| PARTY'S NAME WONJIN AUTOPARTS INDIA PVT. LTD., MARAMALAI NAGAR | | SCALE | | 3:1 |
| ALLOY & TEMPER 6005 T6 | | DRAWING No. | | P-10823 |
| DESCRIPTION TUBE CONNECTOR SECTION | | S2873 | | S2873(ISSUE-3) |

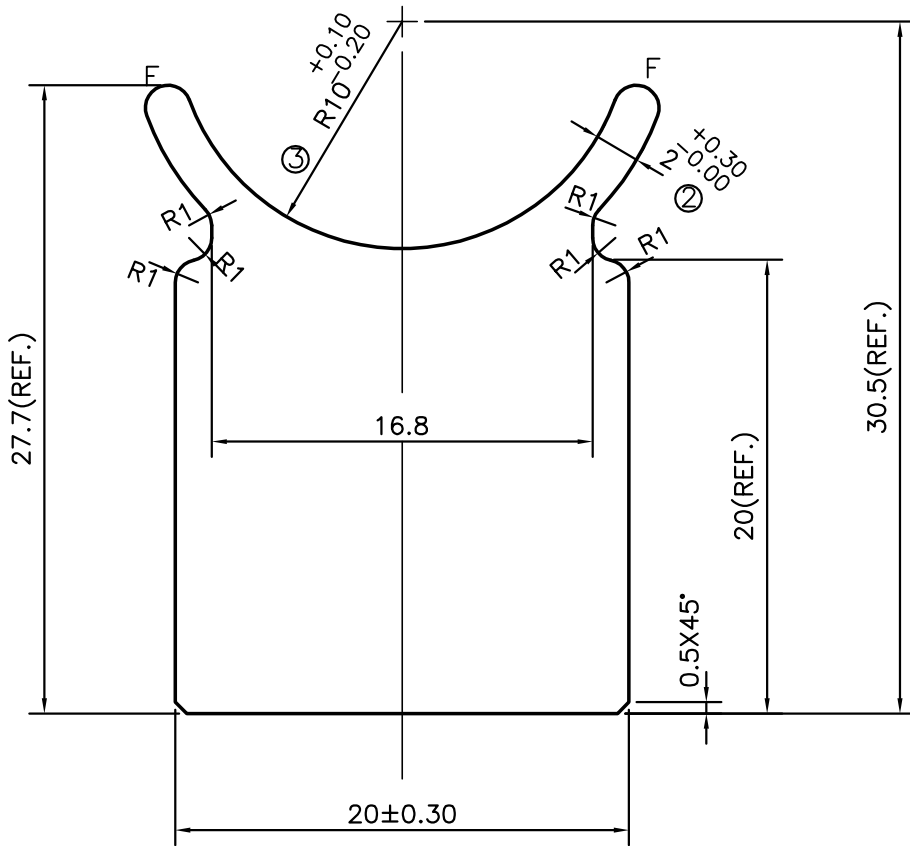
ISSUE-2 :- TOLERANCE CHANGED FROM $R10^{+0.30}_{-0.00}$ TO $R10^{+0.00}_{-0.30}$
& THICKNESS ADDED

ISSUE-3 :- TOLERANCE CHANGED FROM $R10^{+0.00}_{-0.30}$ TO $R10^{+0.10}_{-0.20}$
